Clinton Power Station
8401 Power Road
Clinton, IL 61727

Clinton Power Station, Unit 1
Facility Operating License No. NPF-62
NRC Docket No. 50-461

Subject: Requested Information from June 25, 2015 Regulatory Conference

Figure A - SEM-EDS Evaluations of Sleeve F Interface

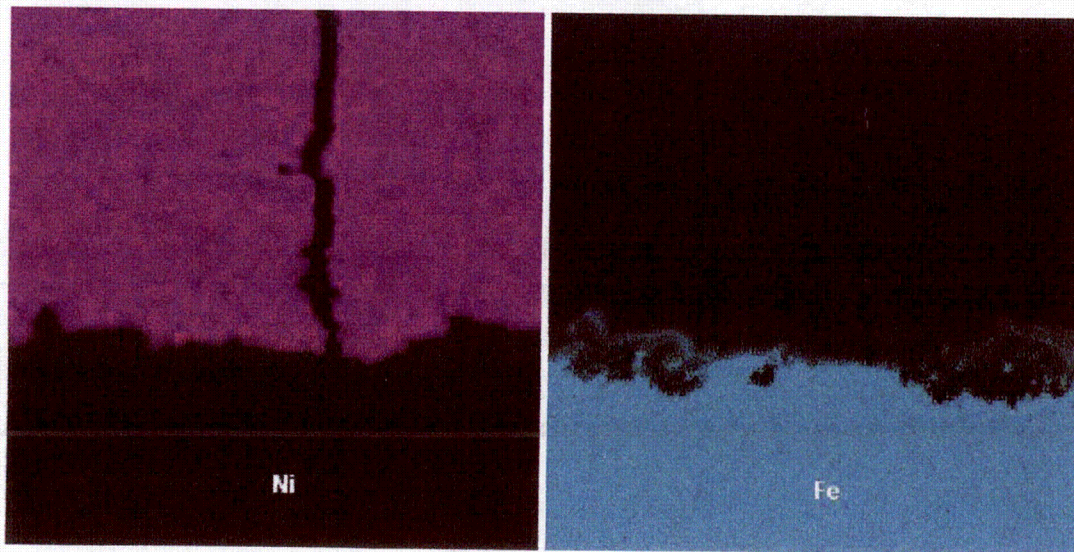
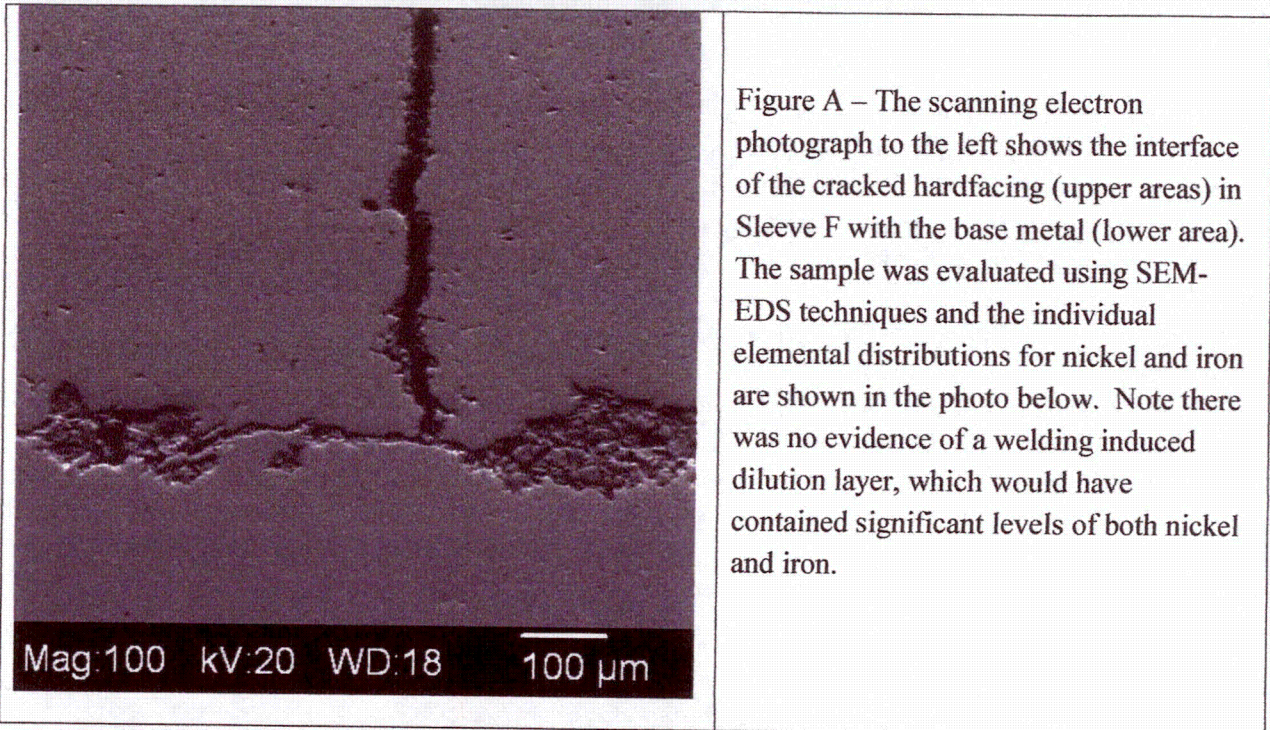
PowerLabs did not find evidence that the hardfacing was welded to the sleeves. Every hardfacing/base metal interface showed a distinct boundary between the sleeve and the coating with no evidence of dilution from welding as shown in Figure A below. Additional metallurgical photos of the interface regions were provided in the following photos of PowerLabs Report CPS-86766.
